# SERVICE BULLETIN

# NACELLE - EXHAUST - THRUST REVERSER - INNER BARREL HEATSHIELD PANDOWN, ENLARGEMENT OF - CATEGORY CODE 6 - MOD.NAC-78-0081

V2500-NAC-78-0081

Enlargement of Pandown Area Fig.2

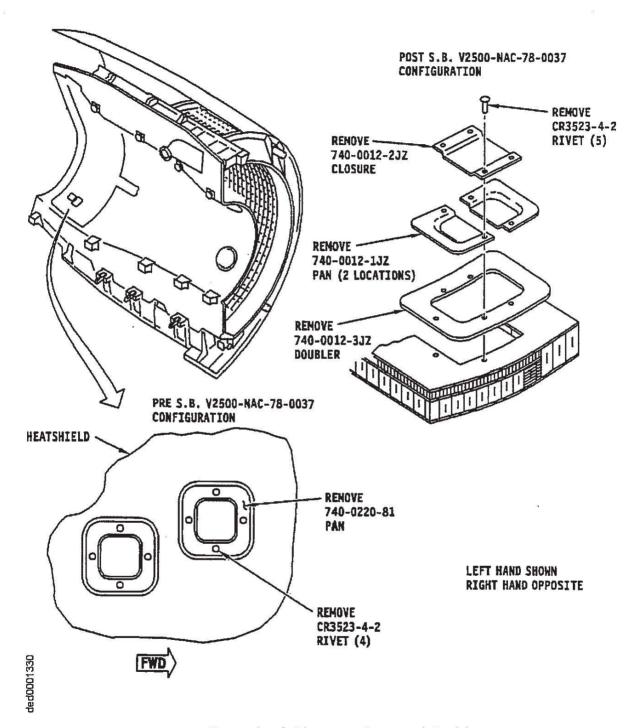
- (C) Cut away heatshield and core to dimensions and shape shown in Figure 2. Depth of core to be removed is 0.25 in. (6.35 mm). Proceed to paragraph 2.B.(4).
- (3) Post SB V2500-NAC-78-0037 -Do the following if Service Bulletin has been incorporated.
  - (a) Remove five CR3523-4-2 rivets that attach closure, pans, and doubler to the inner barrel. (Refer to Figure 1).

Removal of Closure, Pan, and Doubler Fig.1

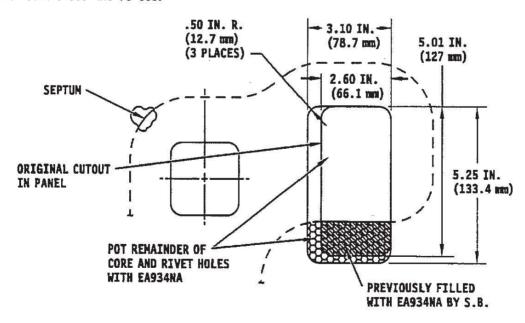
- B. Rework or Modification Instructions Thrust Reverser
  - (1) Find thrust reverser forward pandown located on the left hand aft inner barrel. (Refer to Figure 1.)
  - (2) Pre SB V2500-NAC-78-0037 Do the following if Service Bulletin V2500-NAC-78-0037 has not been incorporated.
    - (a) Remove four CR3523-4-2 rivets that attach the 740-0220-81 pan to thrust reverser inner barrel. (Refer to Figure 1.)
    - (b) Remove 740-0220-81 pan.

- (b) Remove 740-0012-2JZ closure and two 740-0012-1JZ pans. Discard parts.
- (c) Break liquid shim bond between inner barrel and 740-0012-3JZ doubler. Remove doubler and discard.
  - NOTE: If it is difficult to break the bond of the liquid shim, use liquid nitrogen or equivalent to freeze the attachment to make separation of the doubler easier.
- (d) Cut away heatshield and core to dimensions and shape shown in Figure 2. Depth of core to be removed is 0.25 in. (6.35 mm).
  - NOTE: The heatshield will have already been cut back to a depth of 1.25 in. (31.8 mm) on two sides, an inch on one side, and 0.75 in. (19.1 mm) on the remaining side by Service Bulletin 78-0037); therefore only the one side will have to be enlarged from 0.75 (19.1 mm) to 1 in. (25.4 mm).
  - WARNING: METHYL ETHYL KETONE (MEK) IS FLAMMABLE AND VAPOR IS HARMFUL.

Installation of Panel, Doubler, and Zee Doublers Fig.3

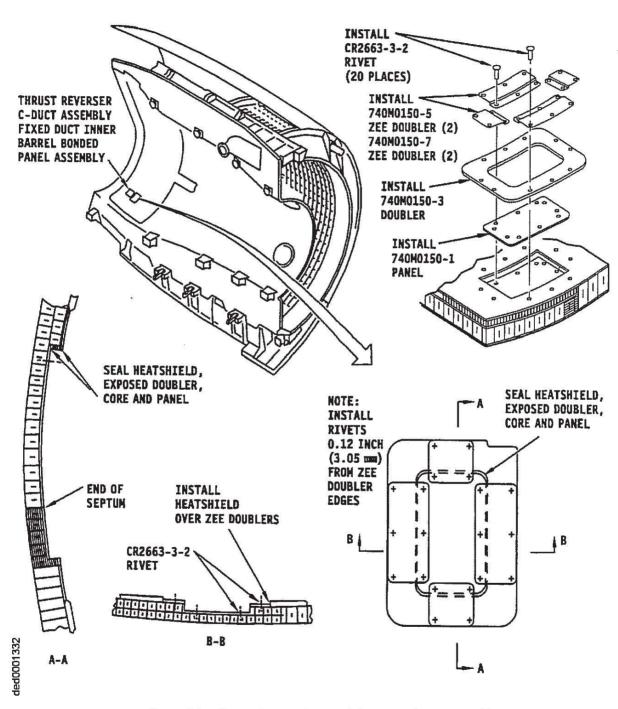
(7) Mix DC90-006 sealant (CoMat 08-032) in accordance with manufacturer's instructions. Apply sealant to 740M0150-1 panel and install panel in cutout area. (Refer to Figure 3.)

- (8) Mix EA9321 adhesive (CoMat 08-078) in accordance with manufacturer's instructions. Apply adhesive to underside of the 740M0150-3, -5, and -7 doublers and put doublers into position below heatshield. Allow to cure for one hour at 200 degf (93.3 degC).

- NOTE: Accelerated cure shown must be utilized to achieve required structual integrity, as normal room temperature cure is five to seven days.
- (9) Make the hole pattern on 74M0150-5 and 740M0150-7 zee doublers. Holes should be 0.12 inch (3.05 mm) from zee doubler edges.

- (10) Drill (20) number 40 size holes through doublers. Burr holes.
- (11) Install (20) CR2663-3-2 rivets.
  - WARNING: PRO-SEAL 700 CONTAINS LEAD DIOXIDE AND MUST BE USED IN A WELL-VENTILATED AREA. AVOID INHALATION OF DUST PARTICLES AND WEAR APPROPRIATE RESPIRATORY PROTECTION. AVOID INGESTION. WEAR APPROPRIATE EYE AND SKIN PROTECTION WHEN USING PR-SEAL 700. WASH THOROUGHLY AFTER HANDLING AND BEFORE SMOKING OR EATING. READ "MATERIAL SAFETY DATA SHEET" FOR PRO-SEAL 700 PART A AND B AND FOLLOW ALL LISTED SAFETY AND HEALTH PRECAUTIONS. PRIOR TO USE OF THIS PRODUCT, CAREFULLY READ THE APPLICABLE 'MATERIAL SAFETY DATA SHEET' AND FOLLOW ALL LISTED SAFETY AND HEALTH PRECAUTIONS.
